**Addendum
To
Acoustic Survey Report
Reference 134976
The Fitzroy Tavern
16 Charlotte Street
London W1T 2LY**

Client: Andrews & Boyd Consultants Ltd

Date: 6th April 2016

Drawing Description:
Third Floor Ventilation Layout

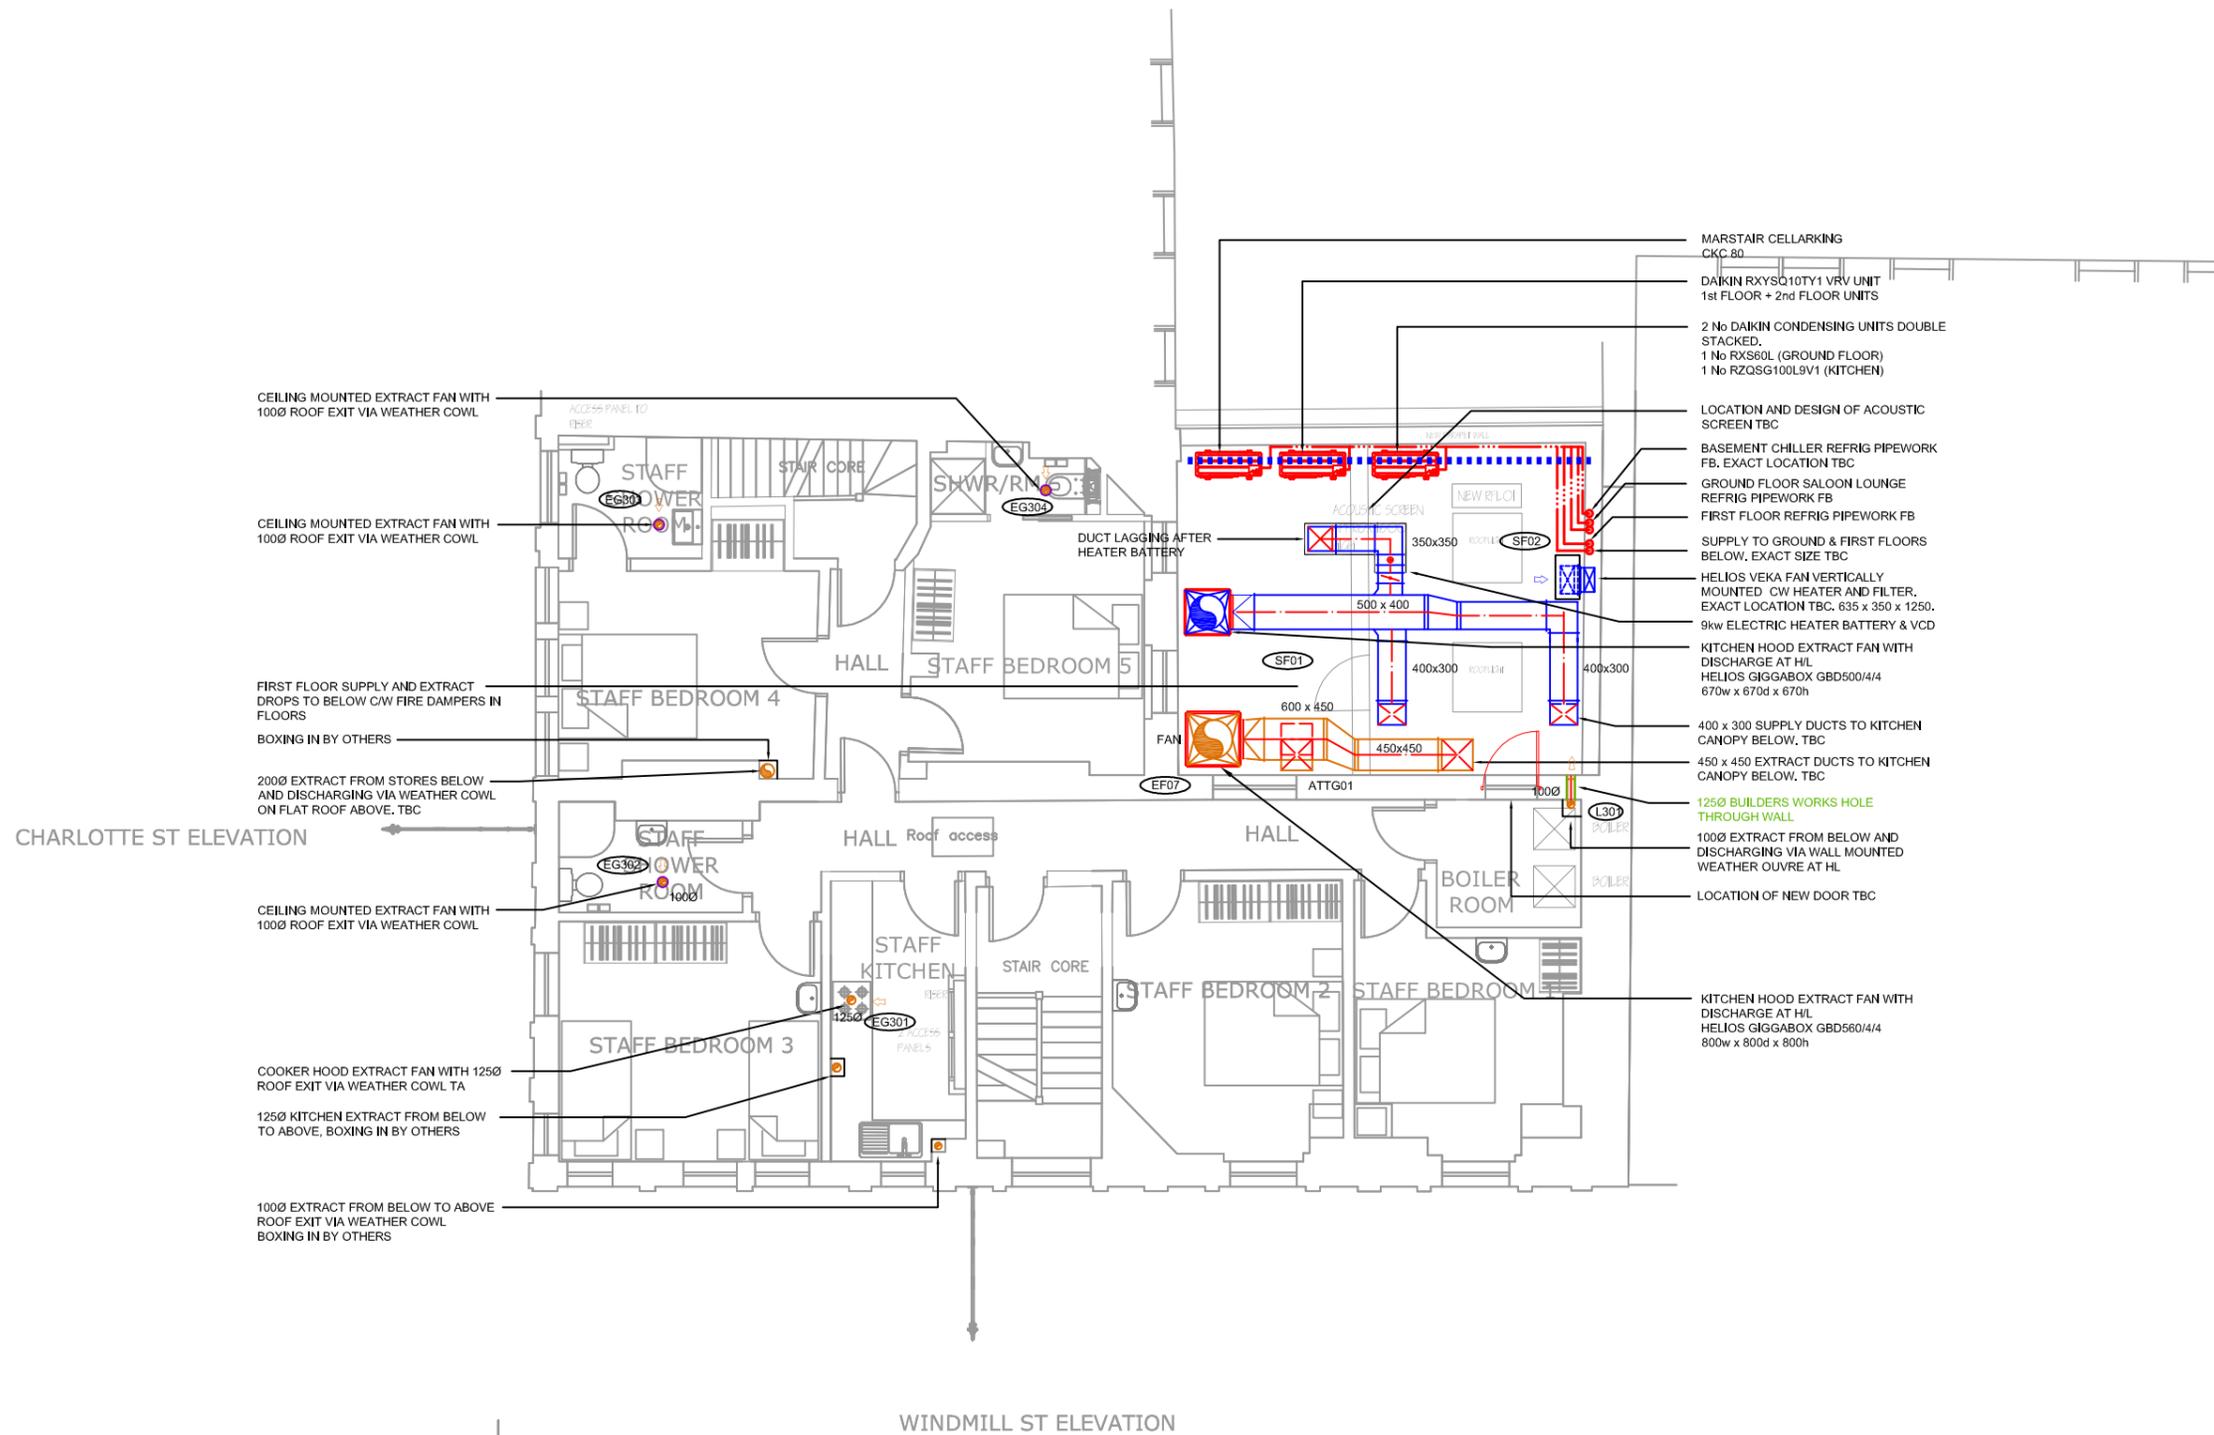
- 3.2 It is understood that screening will be added to the top of the parapet wall generally as marked on the drawing. It is recommended that the screening extend at least 500mm above the height of the tallest condenser and incorporates a ninety degree return as shown to maximise performance.
- 3.3 The closest neighbouring sensitive locations are the windows on the rear façade of 18 Charlotte Street as marked on the Samuel Smith drawing. Taking into account plant distances and screening the closest effective sensitive window is marked on the drawing as location A. All other surroundings are other blank walls or are windows belonging to the Fitzroy Tavern itself.

6.2 The screening should extend at least 500mm above the height of the tallest condenser and should incorporate a return of at least 750mm to maximise the effect.

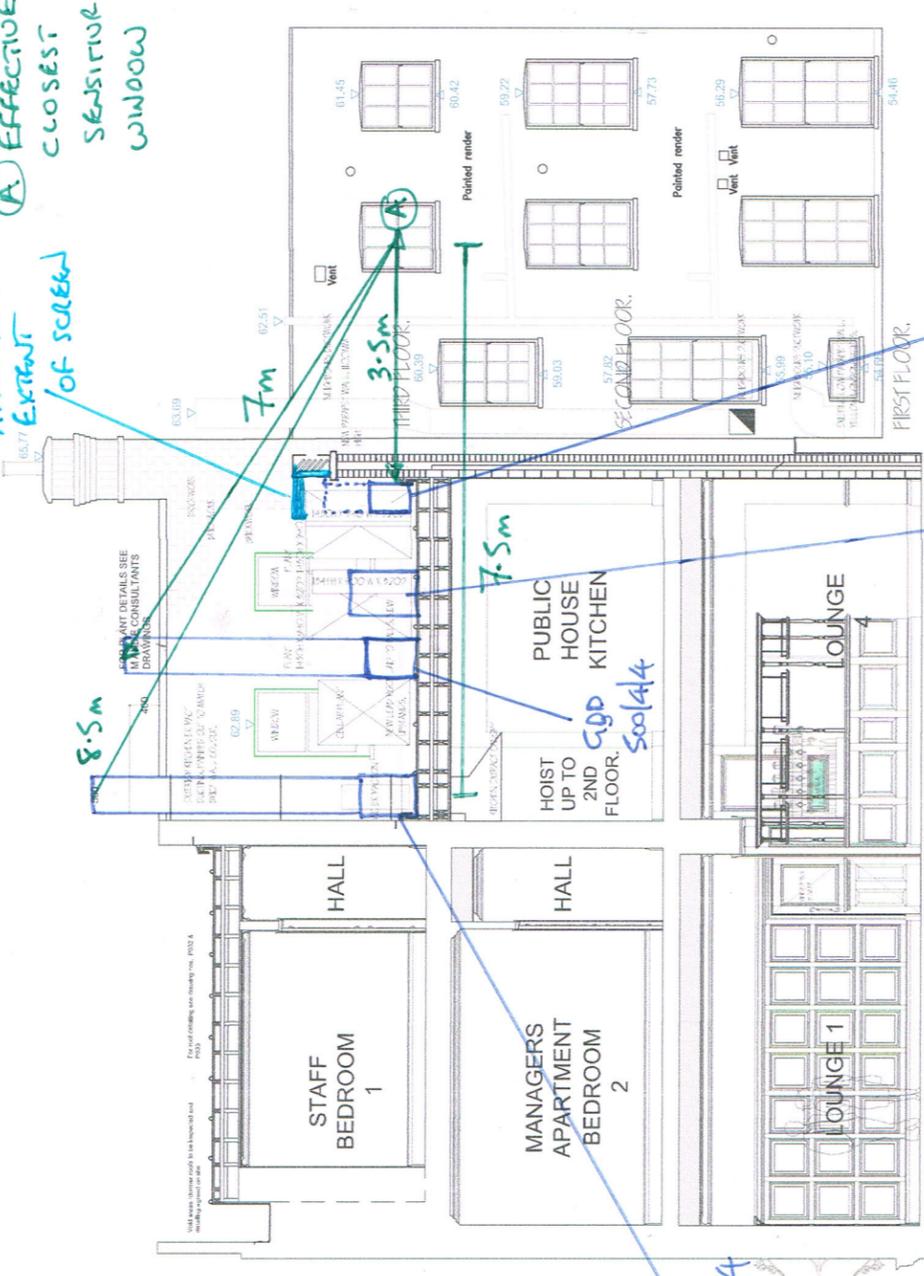
APPROXIMATE
EXTENT
OF SCREEN
EFFECTIVE
CLOSEST
SENSITIVE
WINDOW

CONDENSERS
AND COOLER

VEKA
FAN
